NOTICE OF MEETING
CITY OF GARLAND, TEXAS

Board of Adjustment
Public Meeting
Council Chambers
William E. Dollar Municipal Building
200 N. Fifth Street
Garland, Texas
July 15, 2026
6:30 PM

Board of Adjustment Report

Board of Adjustment Report

SITE PLAN

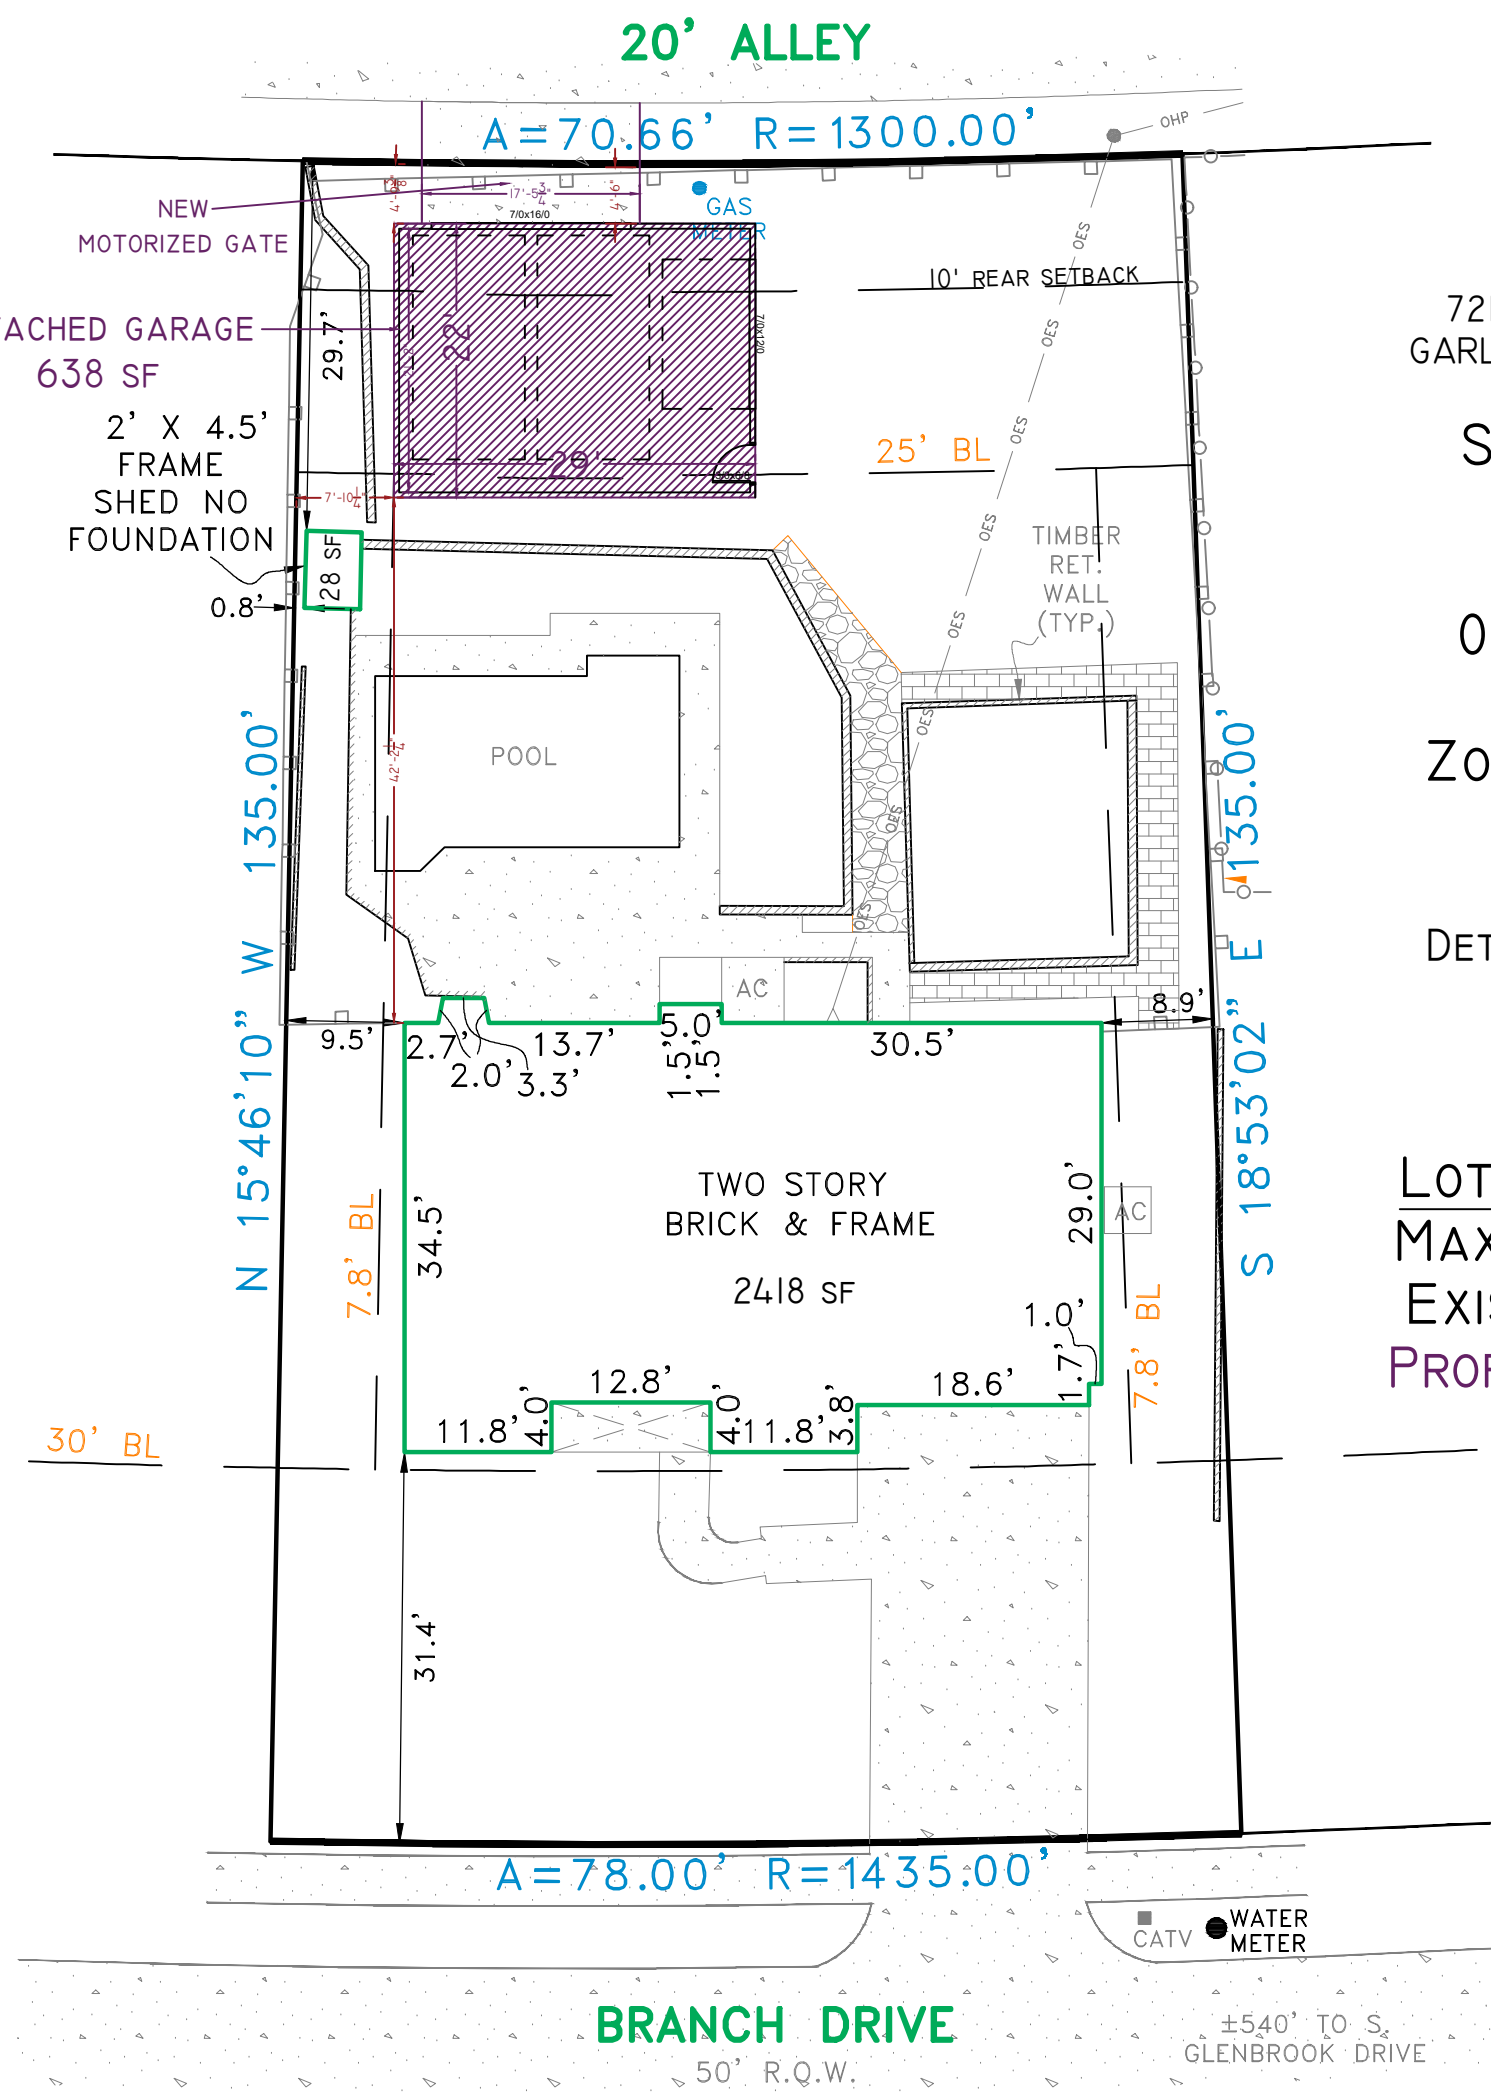
On April 30, 2026, the applicant submitted a permit application for a detached garage on the rear of the property and it was denied. The permit could not be approved because the proposed garage door did not meet the required 20-foot setback from the alley right-of-way line. Based on the site plan submitted, the proposed detached garage would provide approximately 4.5 feet between the garage door and the alley right-of-way line. As the proposed garage did not meet the required setback, the applicant submitted a variance request for the garage door setback to be reduced.

Garage door setbacks adjacent to streets and alleys are primarily designed to provide sufficient area for vehicle maneuvering and to reduce potential conflicts between vehicles entering or exiting garages and traffic within the alley. Based on the site plan submitted, the proposed detached garage would provide approximately 4.5 feet between the garage door and the alley right-of-way line, which does not meet the minimum required 20-foot setback.

The applicant states that the size and shape of the rear yard, along with the location of the existing pool, restricts the ability to accommodate the required 20-foot setback while still allowing construction of the detached garage.

If this request is approved, it will still meet the City's Technical Standards Manual which requires residential garages to be 20 feet or greater in depth or less than 5 feet in depth from the right-of-way, private access drive aisle, or fire lane. The purpose of the less than 5 feet requirement is to ensure there is not enough space for vehicles to park in the driveway and hinder traffic in the alley.

Staff observed a hardship concerning the lot's available space in the rear yard to set the garage 20 feet from the alley. It is up to the Board of Adjustment to determine if a hardship is present.

PLAT SHOWING

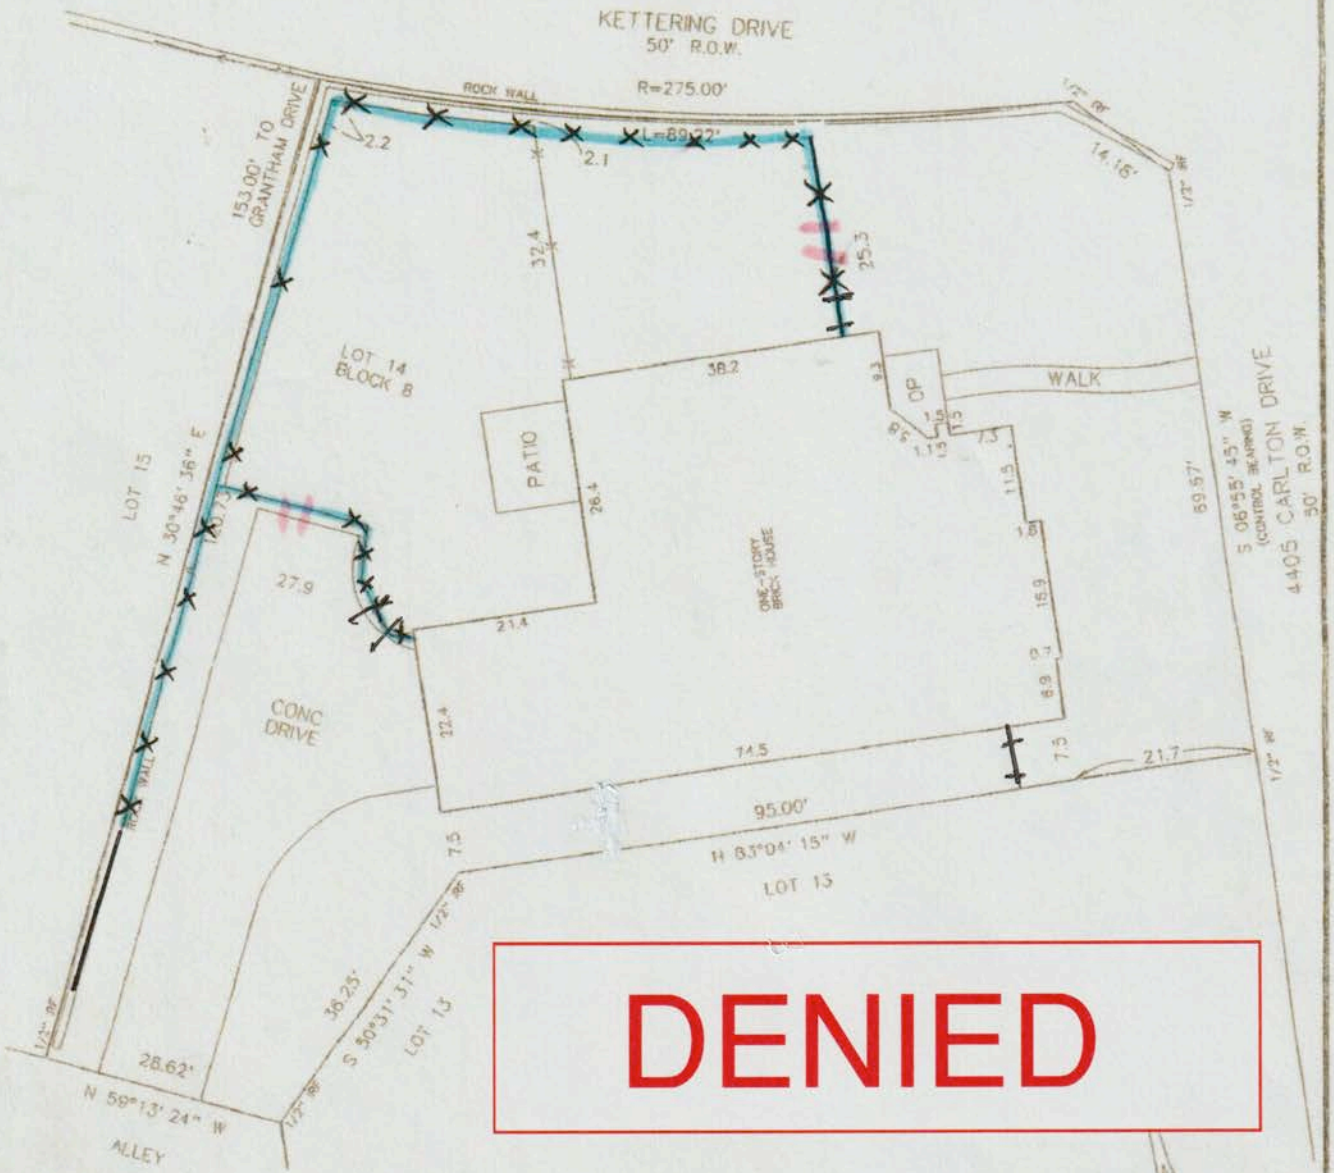
Good morning, your permit application for the (F26-0206) is denied for the following reasons,

- KEY LOT RULES STATE, THE FENCE MUST MEASURE UP TO THE BUILDING LINE OF THE REAR PROPERTY IT BACKS UP TO

KEY LOT RULES STATE, THE FENCE MUST MEASURE UP TO THE BUILDING LINE OF THE REAR PROPERTY IT BACKS UP TO

DENIED

PLAT SHOWING

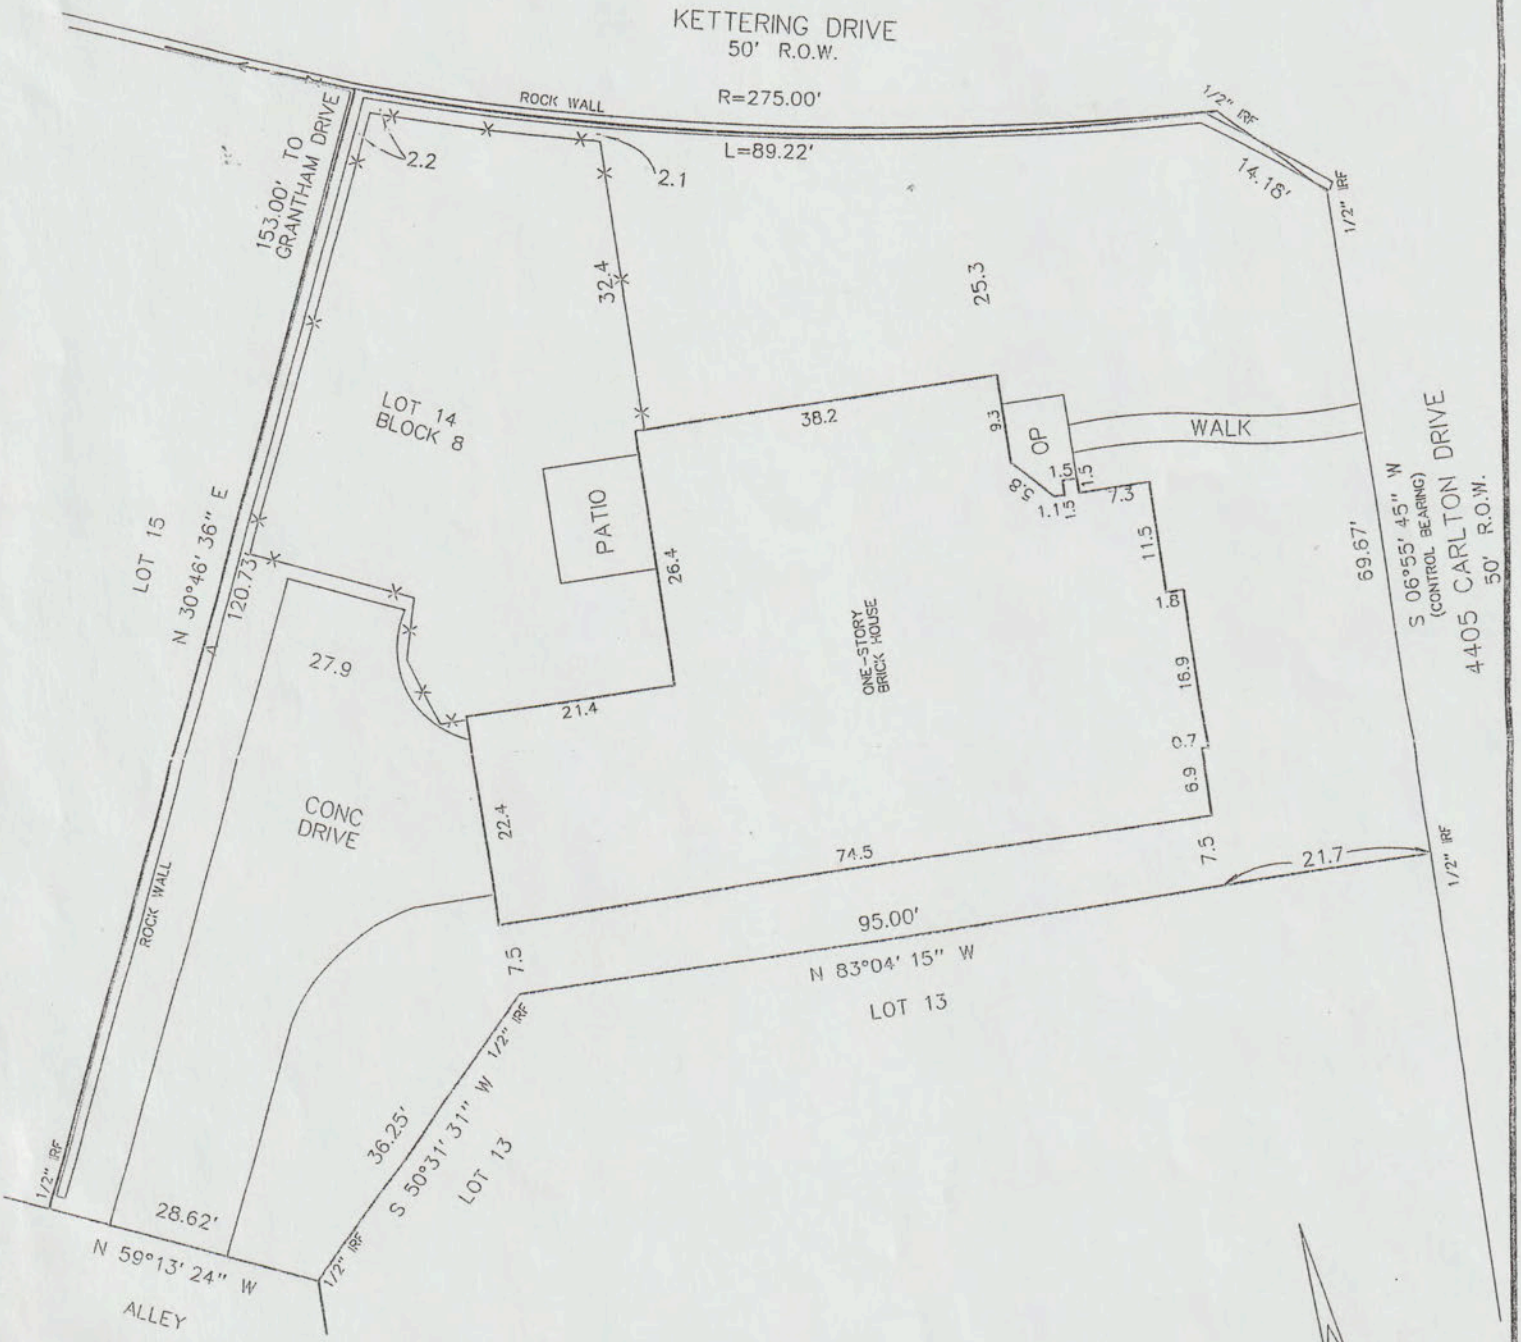
This lot is what we call a key lot and it borders two streets. Being a key lot the area I have highlighted below is considered a front yard meaning you cannot build in this area. Not all corner lots are key lots but it depends on how the development was set and the way the houses face.
